City of Mount Vernon, Ohio

# **CA&C Depot Site Improvements PID 2120509**

## **Addendum No. 1 June 13, 2024**

**CA&C RAILROAD DEPOT SITE IMPROVEMENTS  
SITE PLAN**

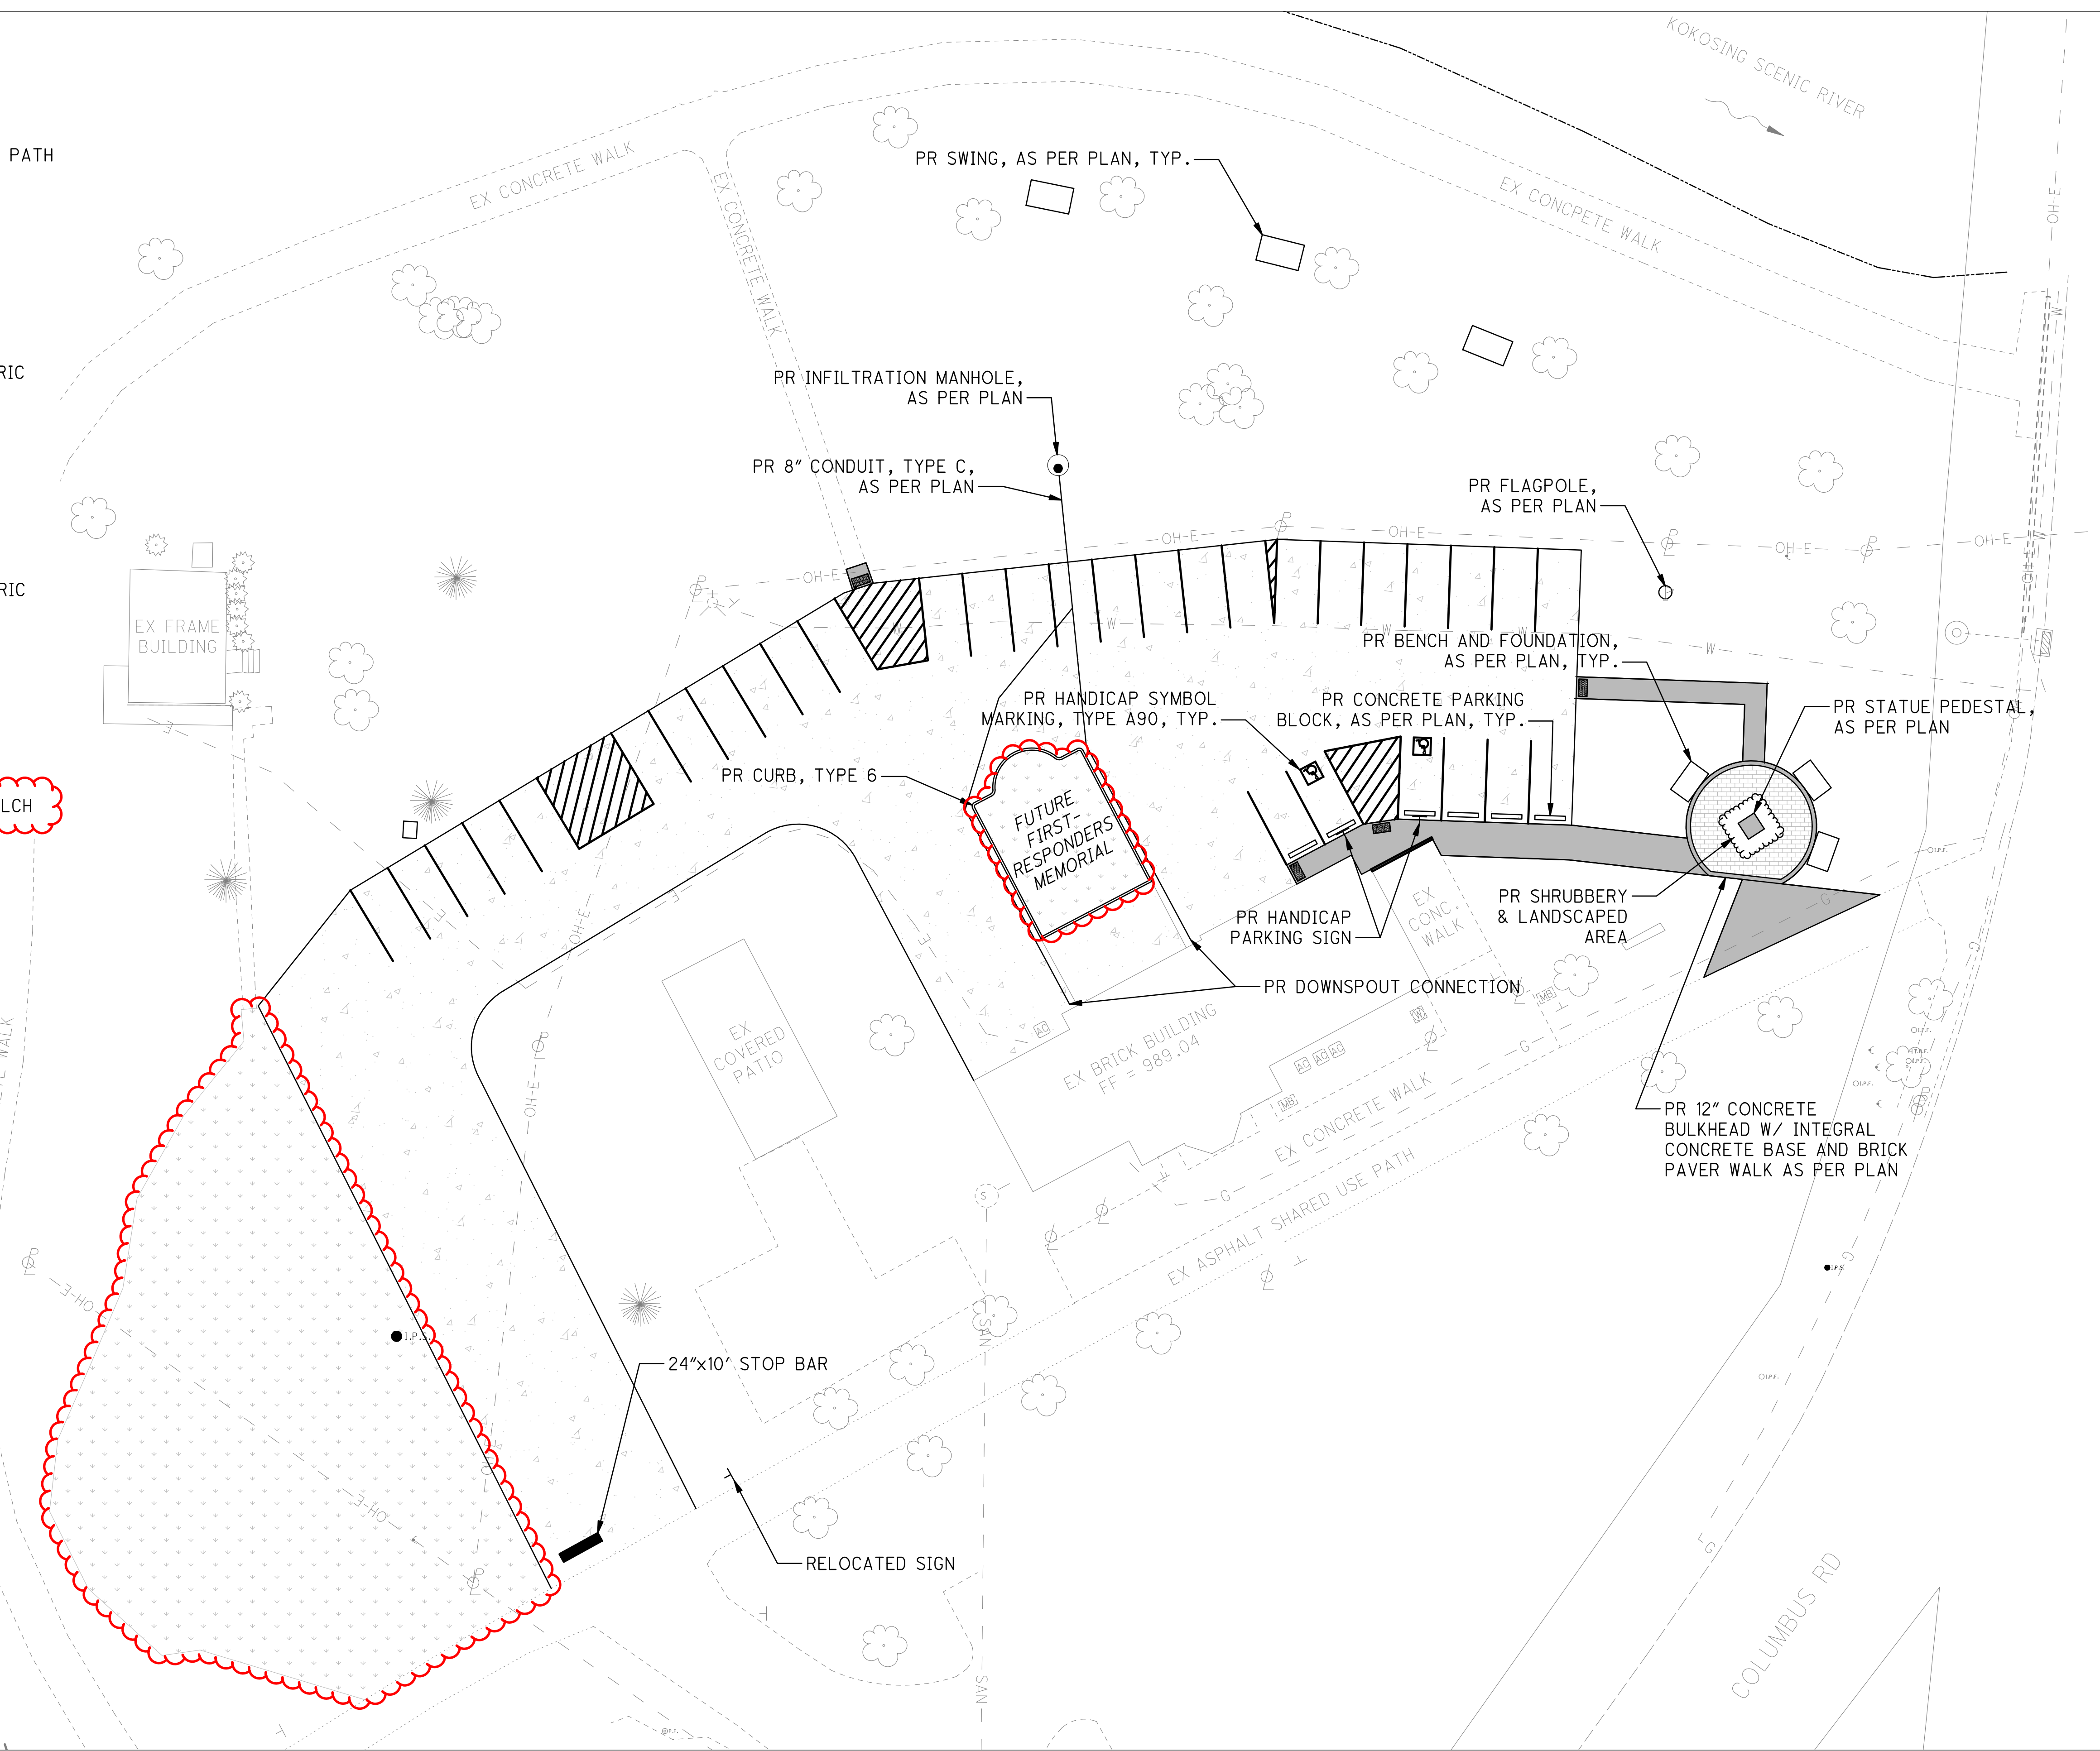
1. Item 690 – Special – Swing Relocated, As Per Plan is no longer needed and should be bid at a price of \$0.00. This work will be performed by others. The price for excavating, prepping, and pouring the concrete swing pad shall be paid under Item 511 – Class QC1 Concrete, Misc.: Swing Foundation, As Per Plan. This pad shall be reinforced in the same way as the bench foundation detail found on Sheet 5.
